INSTALLATION INSTRUCTIONS FOR CODE #1
MODIFICATION KIT #9010-14-00001 TO HXL-1
LINEAR AMPLIFIER

Installation Instructions for Code #2
Modification Kit #9010-14-00002
to HXL-1 Linear Amplifier

BOTTOM VIEW OF TUBE TRAY BEFORE CODE 2 MODIFICATION

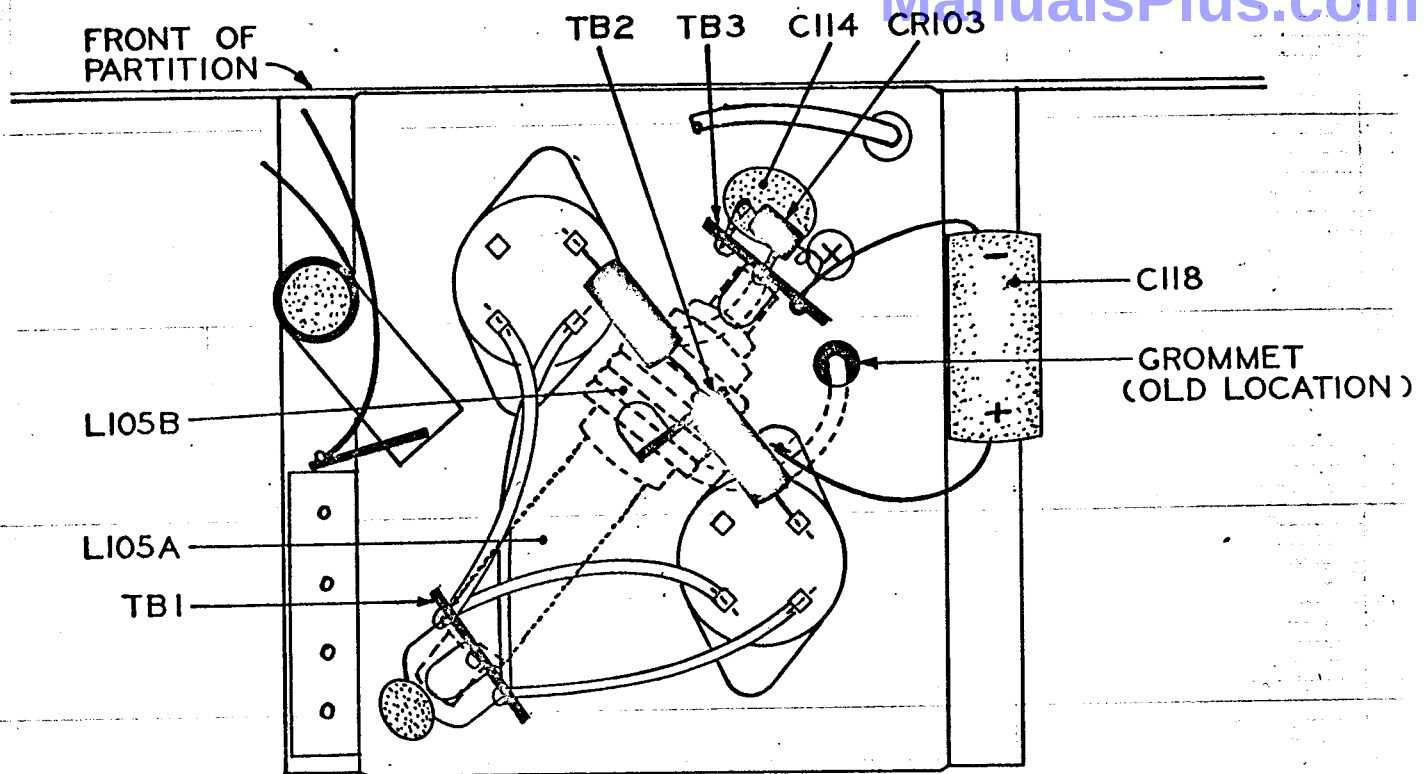
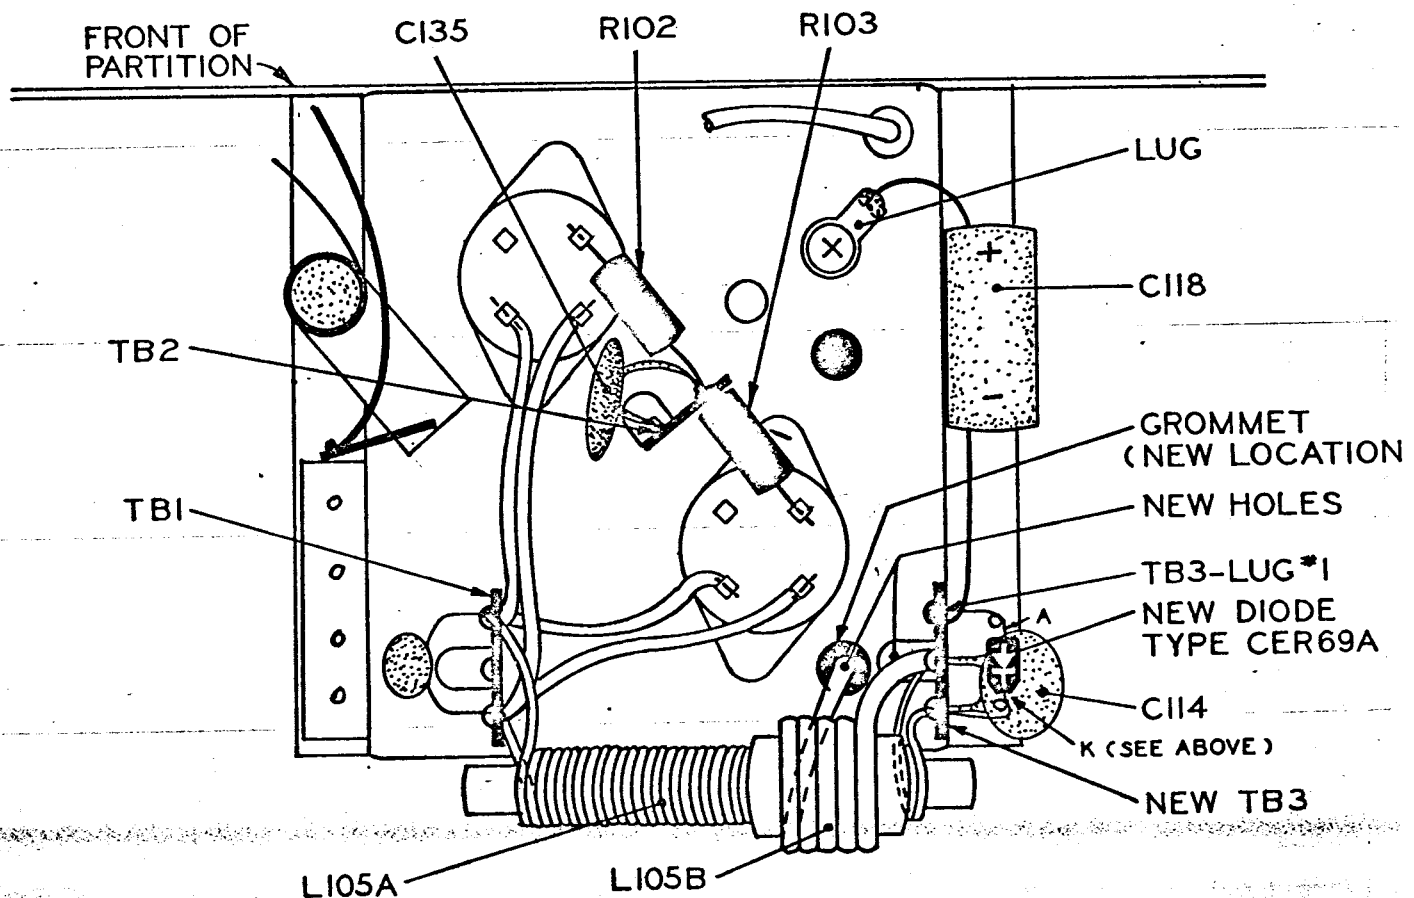
1. Unsolder and remove as a unit, L105A and L105B (Bifilar Coil Assembly).
2. Remove filament wiring (4 brown wires from TB1 to Tube Sockets) and discard.
3. Soften solder on terminal strip TB1 rivet and rotate terminal strip 45° clockwise until parallel with edge of tube tray, as per illustration.
4. Disconnect and remove C118, (250uf capacitor) turn 180° and remount; do not connect at this time.

15. Replace red filament transformer leads to the new terminal strip TB3, lugs 2 and 3. Keep the wires close together and close to the chassis.
16. Mount a new diode (Part #4804-02-00002) Type CER69A between lugs 1 and 3 of TB3. (Cathode end on lug 3, see bottom view, Page 4.)
17. Mount the new .1uf @100V disc capacitor (C114) to the new terminal strip TB3 between lugs 2 and 3.
18. Connect the C118 negative lead to the terminal strip TB3, lug 1.
19. Connect the brown lead from step #6 to the new terminal strip, lug 3.

- ManualsPlus.com
20. Connect white/black lead to the new terminal strip, TB3, lug 1, Shorten wire to fit.
 21. Connect white/blue lead to the junction of R102 and R103 on TB2. Shorten wire to fit.
 22. Add a .01uf (Part #1509-01-01011) C135 disc capacitor to the same point as white/blue lead on TB2 and other end to ground, solder connections.
 23. Add new filament wires between the tube sockets and the terminal strip (TB1) which was rotated in step 3. Keep the wires to each tube close together and close to the chassis. Solder at tube sockets.
 24. Mount bifilar coil assembly (L105A) to the terminal strips. Connections to TB1 are as before. Connections to TB3 are as follows:
 - a. 2 bare leads from L105A to lugs 2 and 3 of TB3.
 - b. Covered heavy insulated lead from L105B to lug 2 on TB3.

Figure shows bifilar coil assembly (L105A & L105B) off to side of tube tray for better clarity of wiring. Assembly is to be mounted directly over terminal strips TB1 and TB3. This is necessary to insure proper operation.

BOTTOM VIEW OF TUBE TRAY AFTER CODE 2 MODIFICATION

BOTTOM VIEW OF TUBE TRAY SHOWING FIELD DRILLED HOLES
CODE 2 MODIFICATION - STEP 12

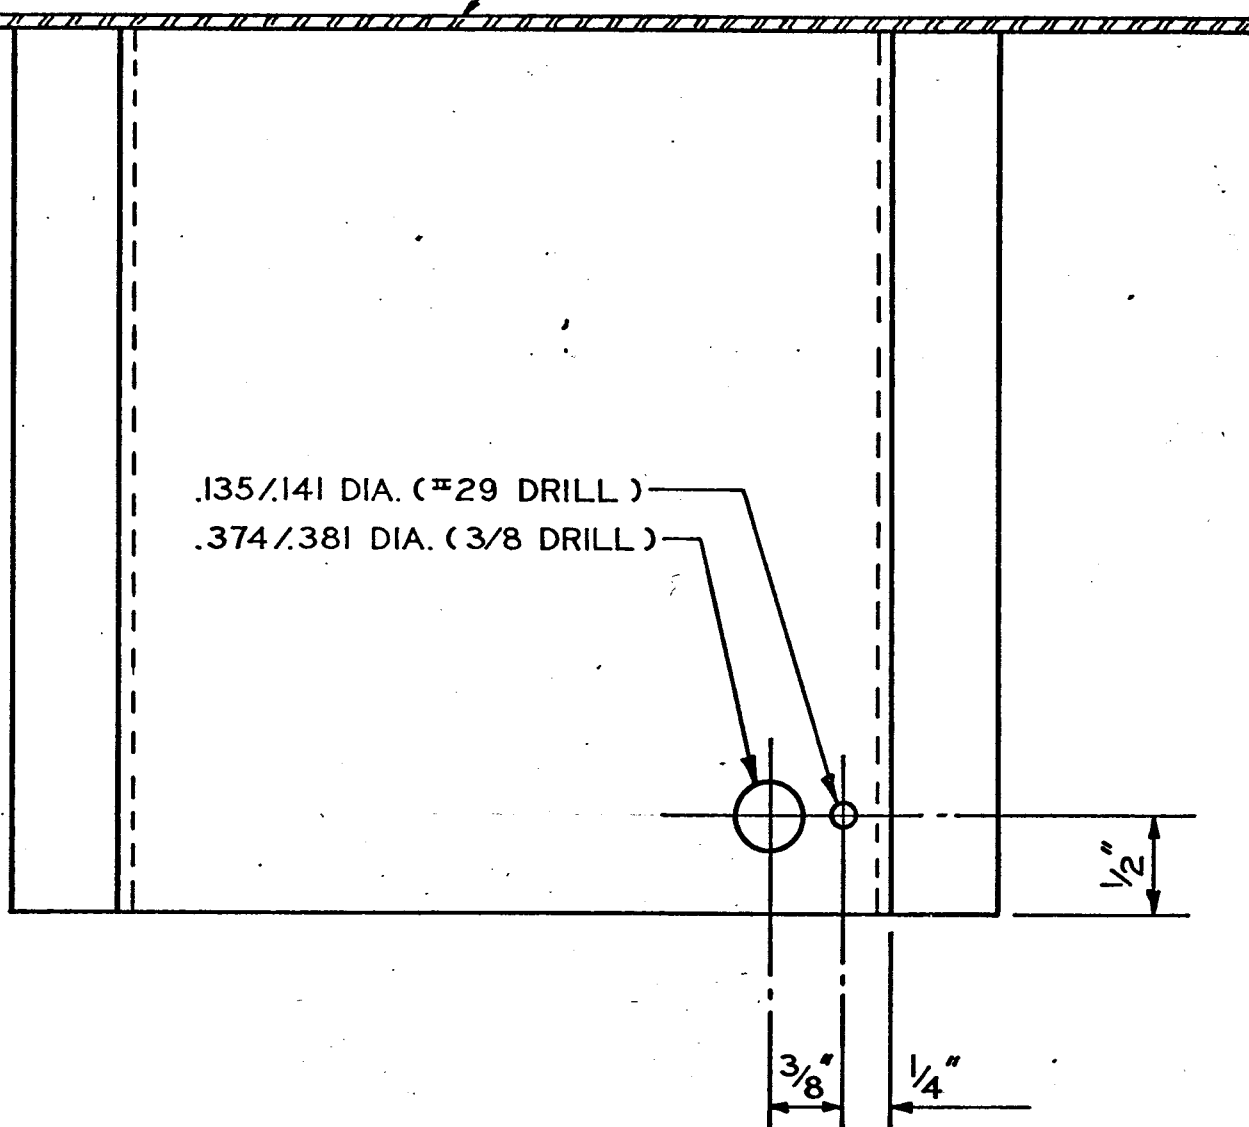
12. Drill (2) holes in tube tray per attached drawing.
13. Mount new terminal strip (Part #2885-01-00012) in the small hole using screw and Keps nut and spot solder to tube chassis. This replaces the old terminal strip TB3.

.135/.141 DIA. (№29 DRILL)

.374/.381 DIA. (3/8 DRILL)
